# Corridor 24-228

*Ion Highway to Boise*

Figure 1. Corridor 24-228

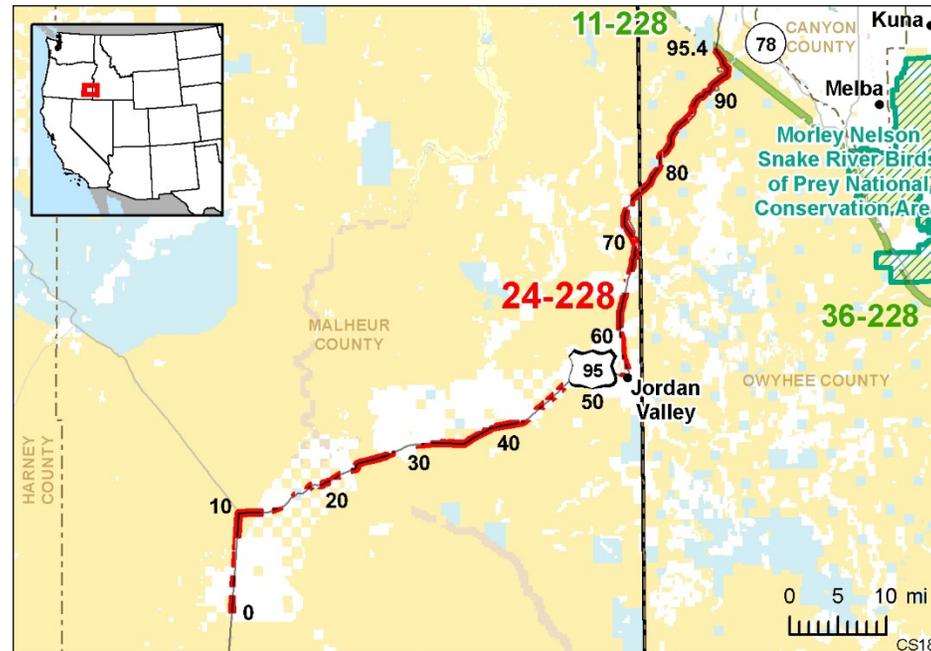
- Corridor 24-228 may not be viable due to significant resource conflicts along Corridors 7-24 and 16-24 to which 24-228 would connect (RFI comment, comment on abstract).

- The corridor crosses NRHP property (Oregon). Re-route to avoid NRHP property (RFI comment).

- The corridor passes through the BLM Alvord Desert WSA. This corridor should not be proposed inside the Alvord Desert WSA (RFI comment).

- Citizens' Wilderness Proposal: Owyhee River Canyon Addition and Saddle Butte (RFI comment).
- Delete corridor (comment on abstract).

- Re-route to avoid "Very High" risk to the number and magnitude of flowline crossings by WWEC segments. Where flowlines must unavoidably be crossed, minimize impacts to connectivity (RFI comment).
- Re-route to avoid pygmy rabbit habitat (Idaho) (RFI comment). Delete corridor due to pygmy rabbit (comment on abstract).

- All possible considerations should be given to the Owyhee River crossing, a watershed not mentioned in the review of areas of interest in the abstract (comment on abstract).

*Analysis:* The intent of the regional reviews is to review all Section 368 energy corridor and provide potential corridor deletions, revisions, and additions. Stakeholders are encouraged to provide potential corridor revisions to ensure that the Section 368 energy corridors meet the siting principles identified in the Settlement Agreement.

*Analysis:* The Pelota Fronton NRHP site is located on private lands and therefore is not within the designated corridor. Section 106 of the NHPA requires federal agencies to consider the effects of an undertaking on cultural resources listed on the NRHP.

*Analysis:* The corridor begins near the boundary of the Alvord Desert WSA but does not intersect the WSA. The corridor follows Highway 95, which forms much of the eastern boundary of the Alvord Desert WSA. The location of the WSA prevents Corridor 24-228 from connecting to Corridors 7-24 and 16-24, preventing a continuous corridor network through southern Oregon.

*Analysis:* The BLM's current inventory findings will be used in land use planning analyses related to the revision, deletion, or addition to the energy corridors. At such time that citizen's inventory information is formally submitted, the BLM will compare its official Agency inventory information with the submitted materials, determine if the conclusion reached in previous BLM inventories remains valid, and update findings regarding the lands ability to qualify as wilderness in character. Agencies could consider an IOP to provide guidance on the review process for applications within corridors with incomplete inventories. The potential IOP would assist with avoiding, minimizing, and/or mitigating impacts to lands with wilderness characteristics.

*Analysis:* Existing IOPs and BMPs would be required, including an IOP for surface water, although in general the corridor follows existing infrastructure. The Agencies could consider an IOP for habitat connectivity so that transmission projects within Section 368 energy corridors are sited and designed in a manner that minimizes impacts on habitat connectivity.
